4054 7TH AVE NE
SEATTLE, WA 98105
DESIGN REVIEW:
RECOMMENDATION PROPOSAL
JULY 03, 2021
SDCI PROJECT NO. 3034988-LU
APPLICANT TEAM
OWNER:
WPI Real Estate Inc.
ARCHITECT:
Z O ARCHITECTURE LLC

RESPONSE TO CITY'S PRIORITIES & RECOMMENDATIONS for EDG -1

3D MODEL SHOWS THE SOUTH FAÇADE FACING THE NEIGHBOR'S APARTMENT BUILDING (UNDER CONSTRUCTION)

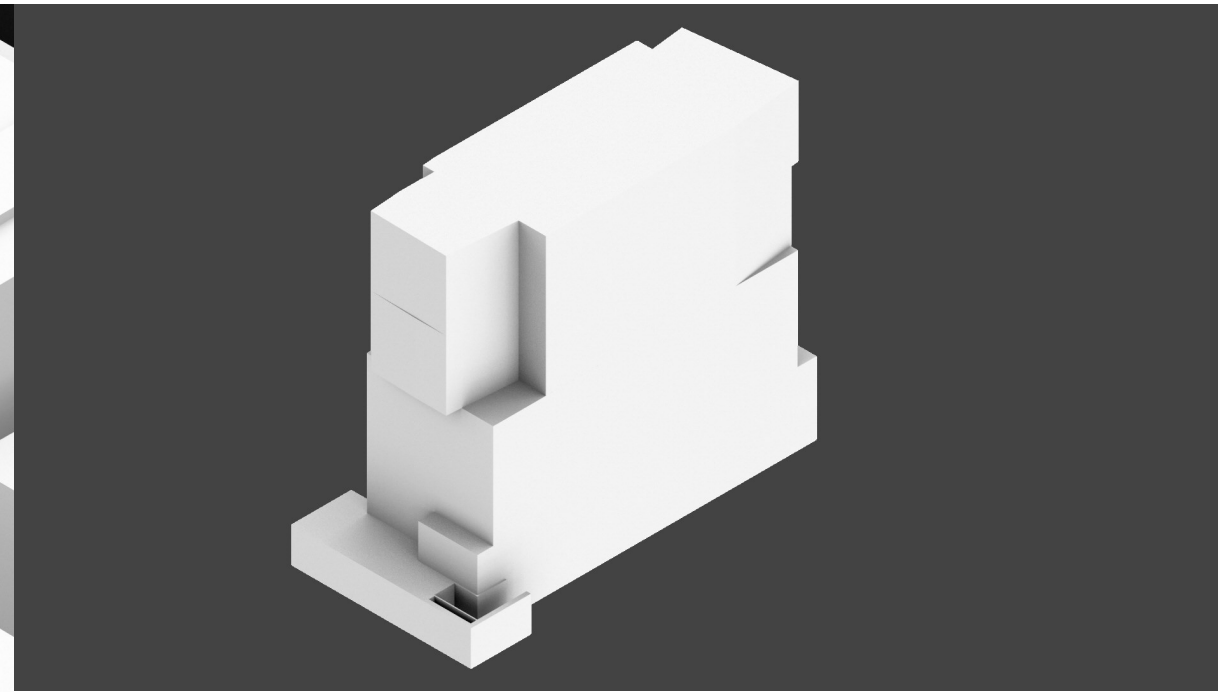
a) Staff agrees that the applicant's preferred option is the strongest proposal. The building will be much larger than most around it. For this reason, it is important that the building have visual interest on all sides. Overall, the plane shifts presented in option one does the best job of creating a building that has visual interest expressed on its sides as well as its front. (CS2, CS3, and DC2)

b) While the rest of the massing has the potential to provide a cohesive design concept, the lower plane shifts of the preferred option seem arbitrary. This area should be refined or further defined in the Recommendation Packet. (DC1 and DC2)

The design creates random balconies and terraces spaces for each unit and full height windows at upper levels with railing protection. The project uses lush and layered landscaping at street level to create a welcome frontage and a landscape buffer to the pedestrian.

The project will follow the privacy requirements when designing balconies and other outdoor areas and windows in habitable rooms including bedrooms. The design will take into consideration not lining up the windows to the neighbor's building (see page 38 privacy elevations).

After giving more space to the street front the current design carefully shapes the massing at the side and rear yard to make better relationships with both surrounding existing buildings and the apartment building under construction on the south side. Massing concepts (see page 18)

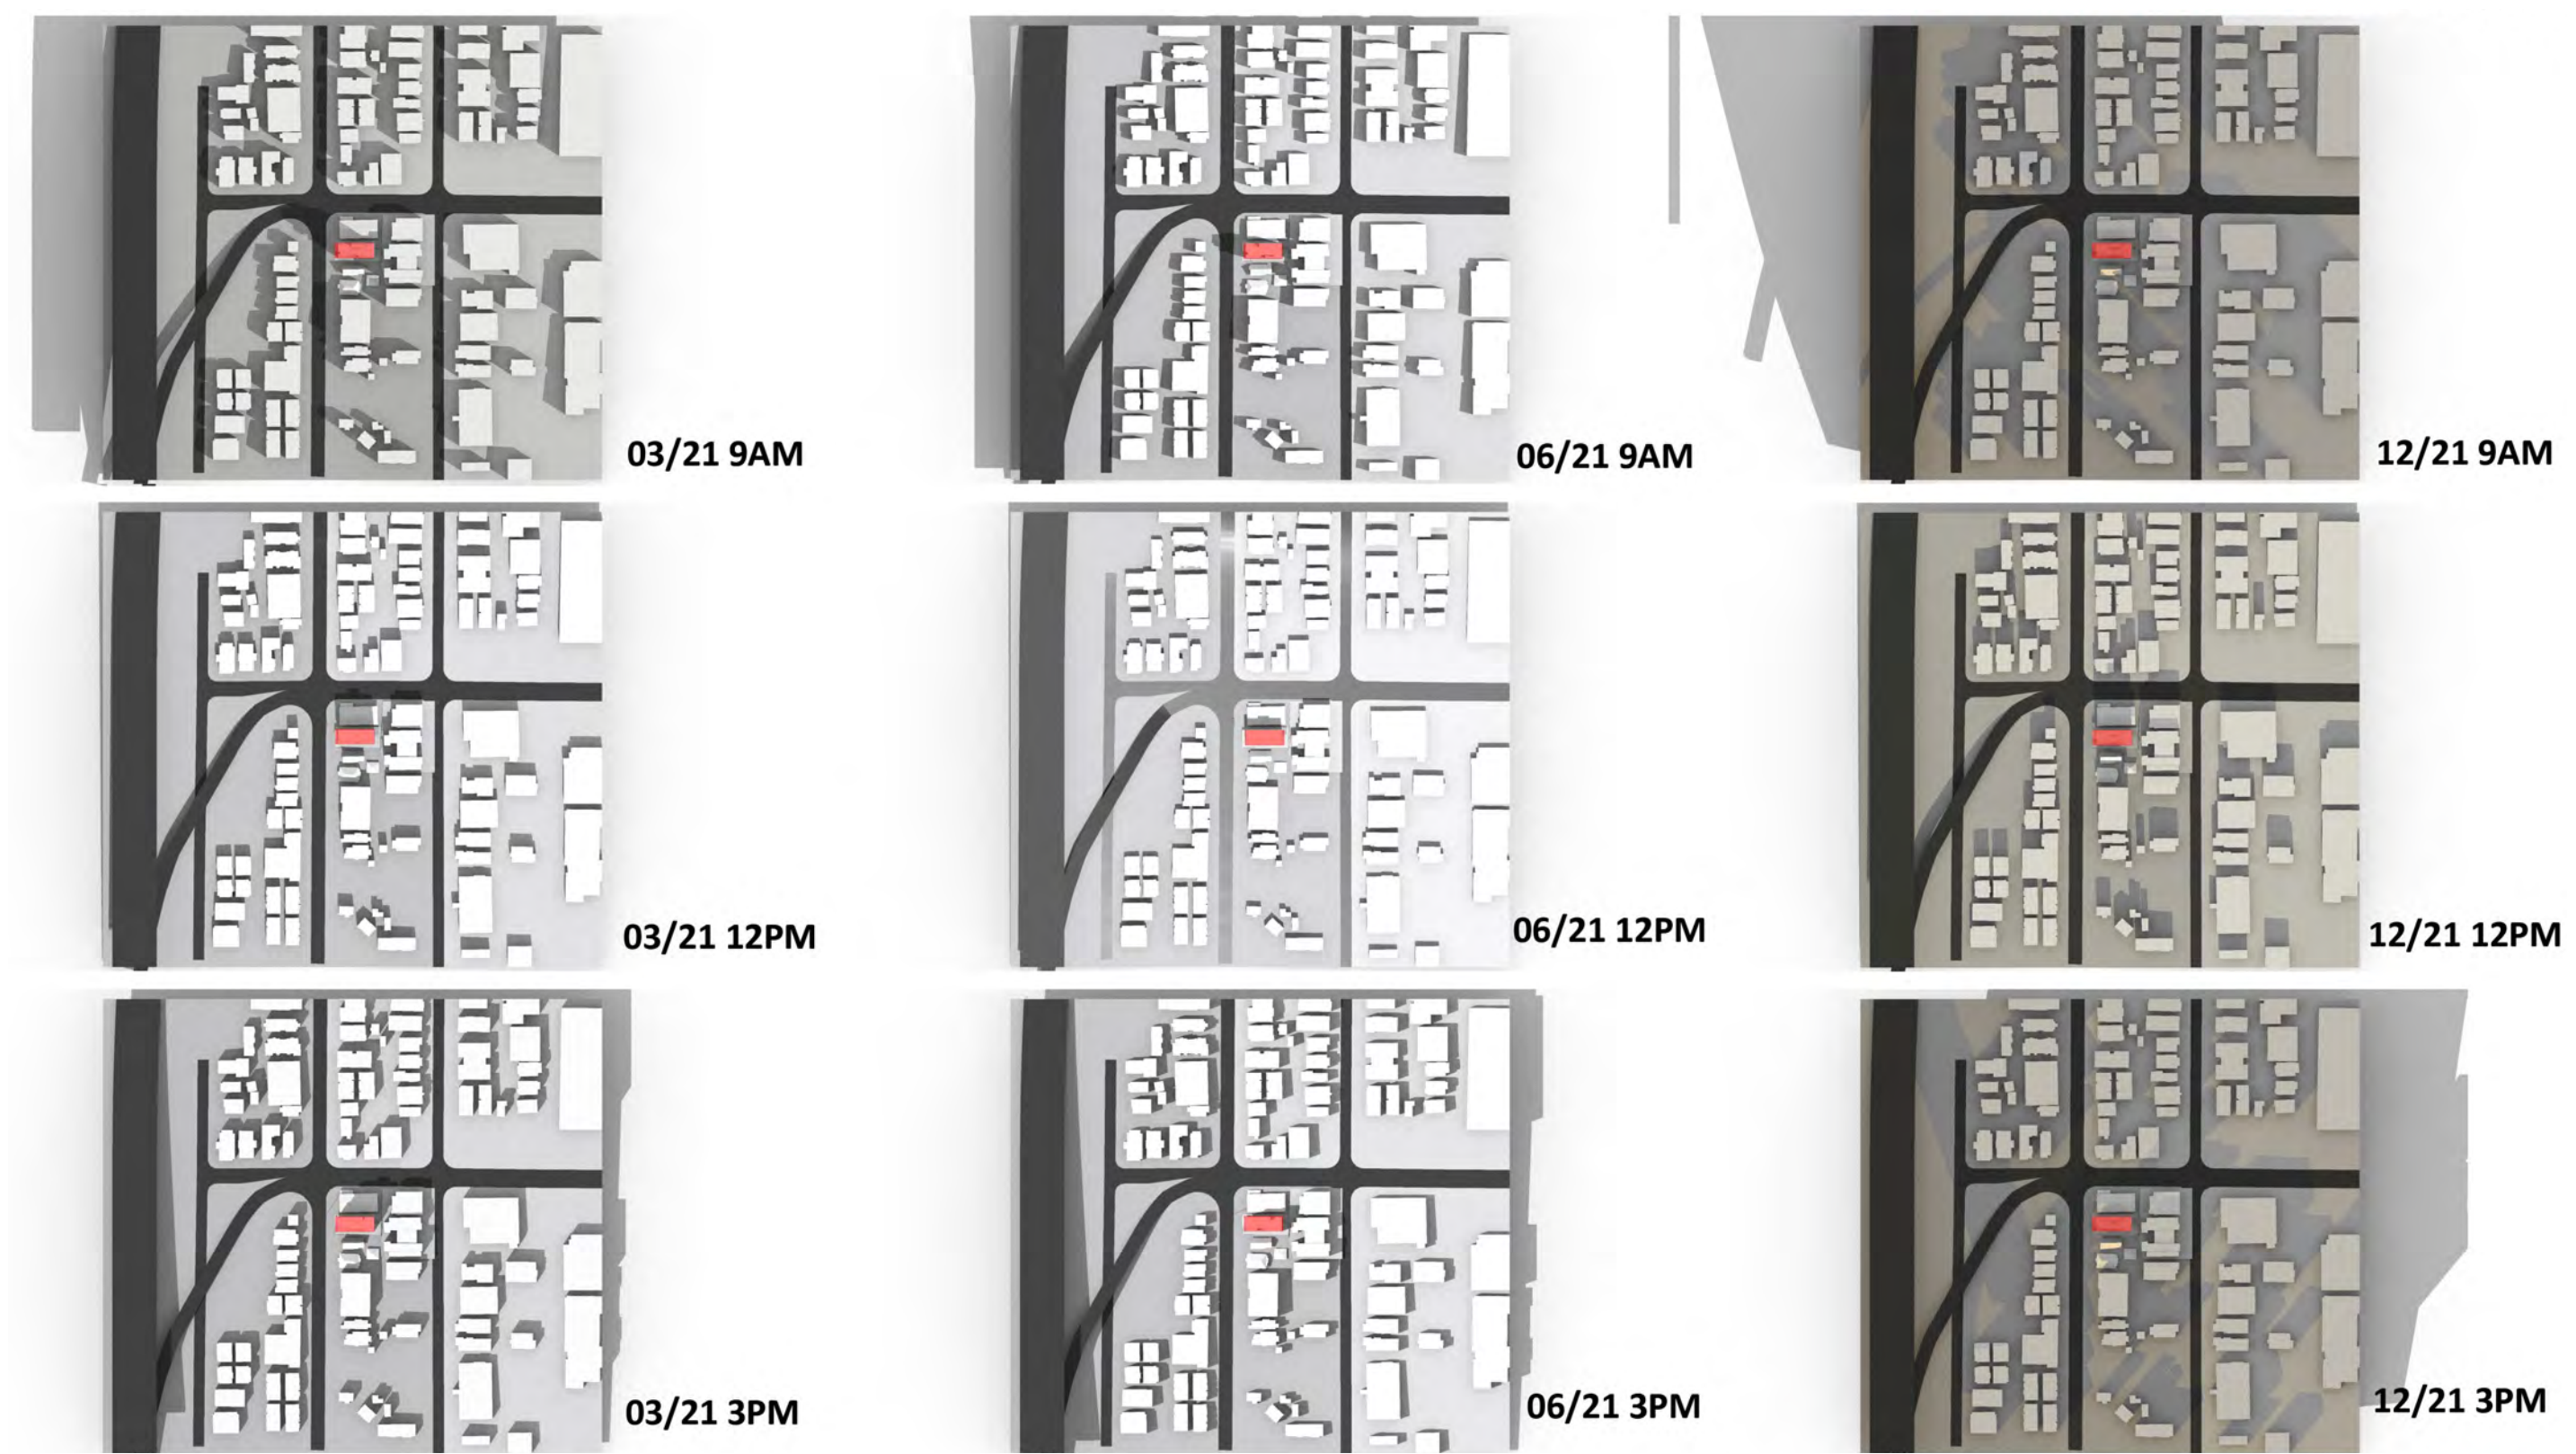
a) To meet the guidelines, the proposal should be designed with a strong connection to the street. The easiest way to achieve this is to create a direct connection with a door that faces the street. For the south-facing door to meet design guidelines, the walkway to the door must create an inviting space with visual layers, seating, and other forms of activation. It is also critical that vibrant landscaping that is tolerant to site conditions and pedestrian activity is placed in the area between the building and the street to create a positive experience for pedestrians. (PL1-1-a. Engage the Public Realm, PL1, and PL3)

b) The entry volume in the preferred option is much larger than the surrounding context. Explore lowering the height of this volume or study how the volume relates to the surrounding context. (PL3-1-a. Prominent Design, PL3, and DC2)

c) The EDG packet includes lush landscaping references with human-sized places and high-quality pavers, seating, and natural fencing. This should be included in the recommendation proposal. (PL1-1-a. Engage the Public Realm, DC4-2-b. Fine-Grained Texture, PL1, PL3, and D3)

The design rotates the south-facing entry door slightly west towards the front street creating a more welcoming entry front space with seating at the doorway surrounding with a nice landscape. Create the natural landscape buffer by planting bamboo close to the property line to the south neighbor's building (see pages 11-13, 34,-37).

The taller 2 story entry volume is designed based on propositions to fit this 9 story building. The stone wall carries the same materials from outside to inside with a very visible welcoming lobby from the street. It also fits very well propositionally with the north neighbor's 2 story apartment and the south neighbor's new apartment building (see pages 16, 11, 53, 54).

The design will use high-quality durable pavers for the front entry with the landscape surrounding the seating area (see pages 16, 11, 53, 54).

DEVELOPMENT STANDARD DEPARTURES

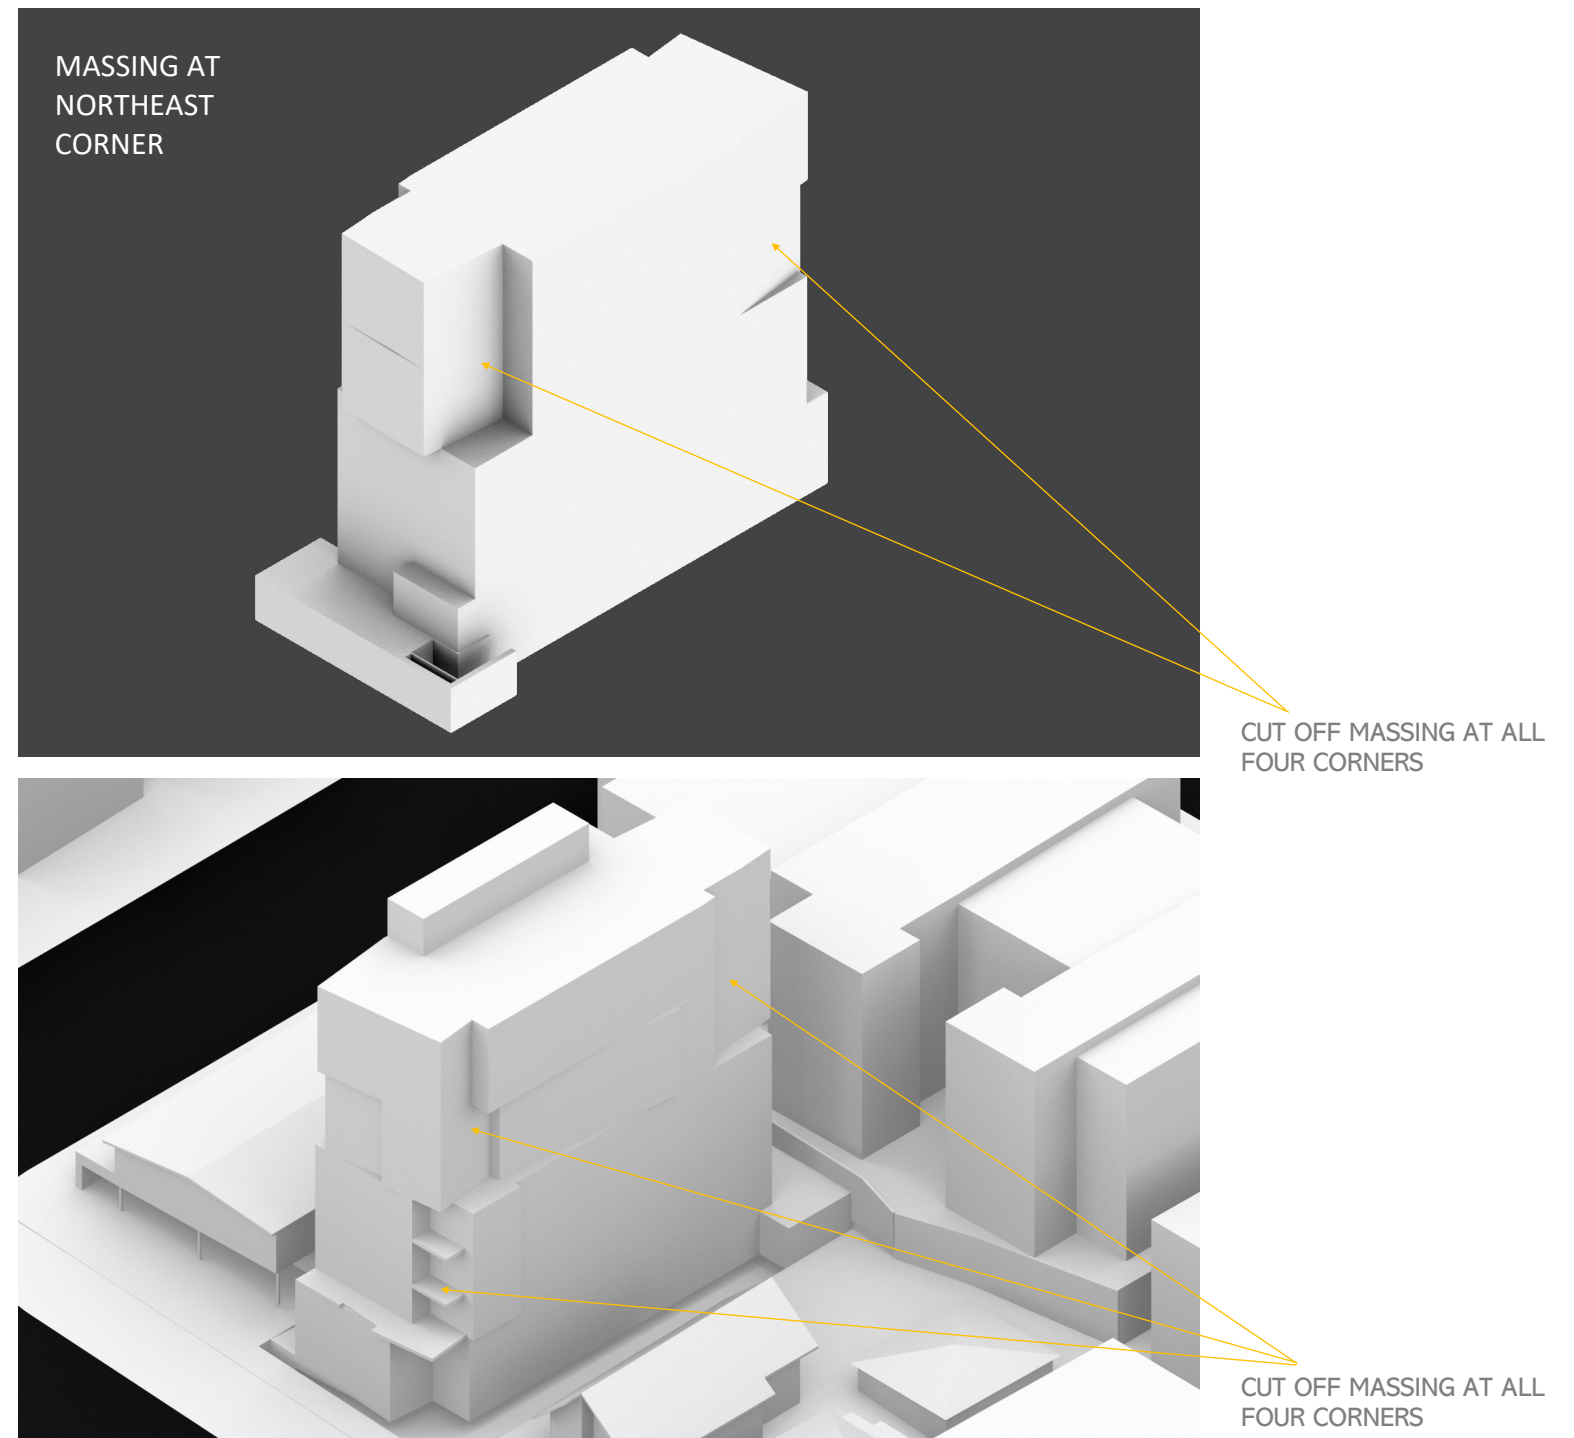
Staff preliminarily supports this request. The departure allows for a dynamic sculpted shape that helps to mitigate the height of the building and provides visual interest at all sides.

1. Side Setback from Interior Lot Line (South) (SMC 45.518.B): The Code requires a minimum of 10' average setback from the lot line above a height of 42 feet above grade. The applicant proposes a reduction to the north setback to an average of 8'8" above a height of 43' above grade.
